TECHNICAL BULLETIN DISTRIBUTION

IBD Lighting Conversion to LED

Flavor Shot 30" IBD Carbonator Conversion

Technical Bulletin Reference No. 2501-002

New Cold Plate Assembly, PN: 09-0338

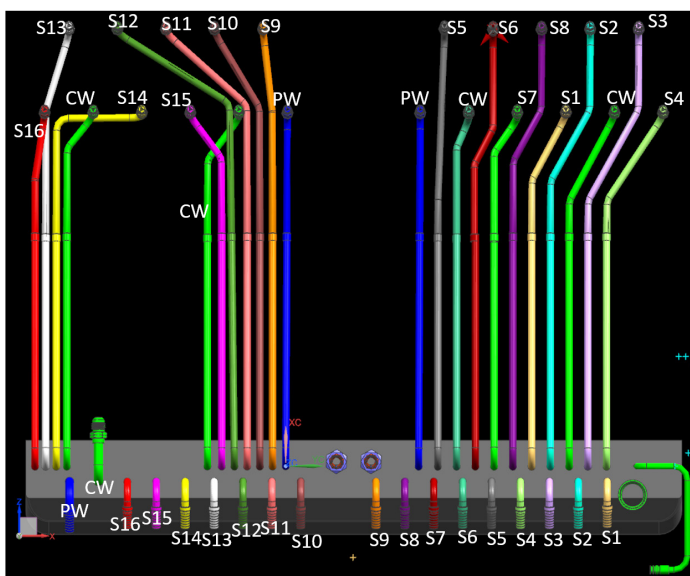
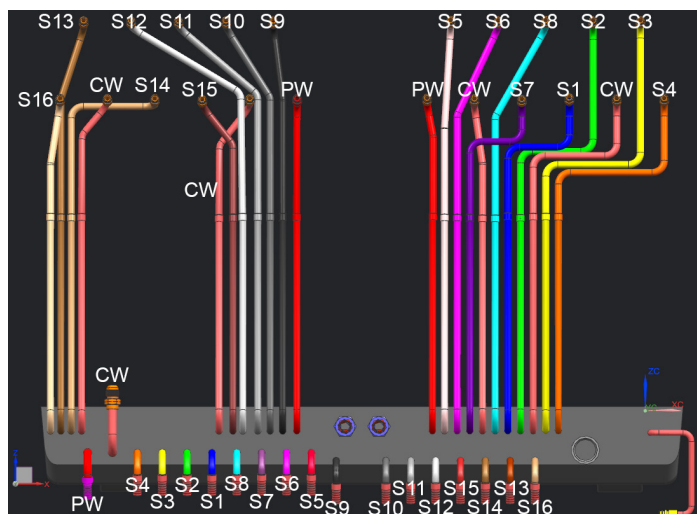
Beginning in May 2018, the Flavor Select (FS) 30" dispenser will no longer come equipped with the square "picture frame" carbonator assembly, but will be replaced with the cylindrical, "muffler" carbonator assembly. The cylindrical carbonator is easier to maintain, service, and manufacture.

This change also affected the syrup and water lines in the cold plate assembly. The syrup/water lines had to be re-configured in order to fit the new carbonator assembly, which altered the order of the inlets.

New Plumbing Diagram, PN: 06-3600

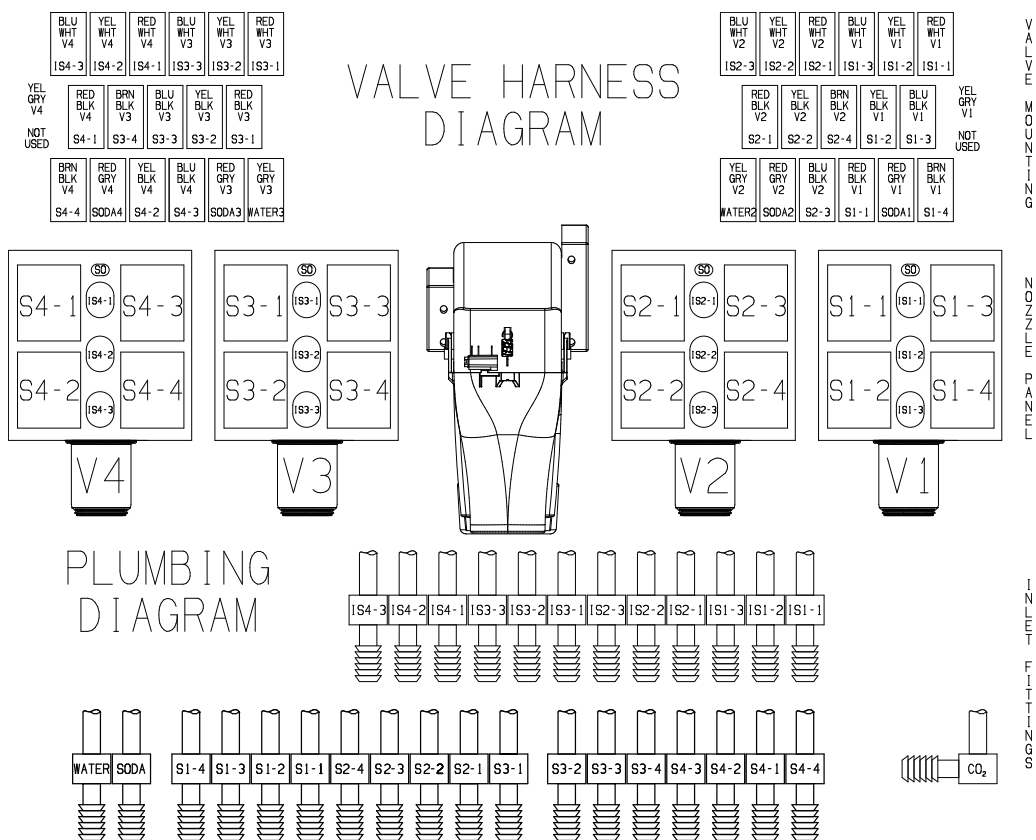
An updated plumbing diagram will be provided on the unit, as well as on the unit's manual and installation guide.
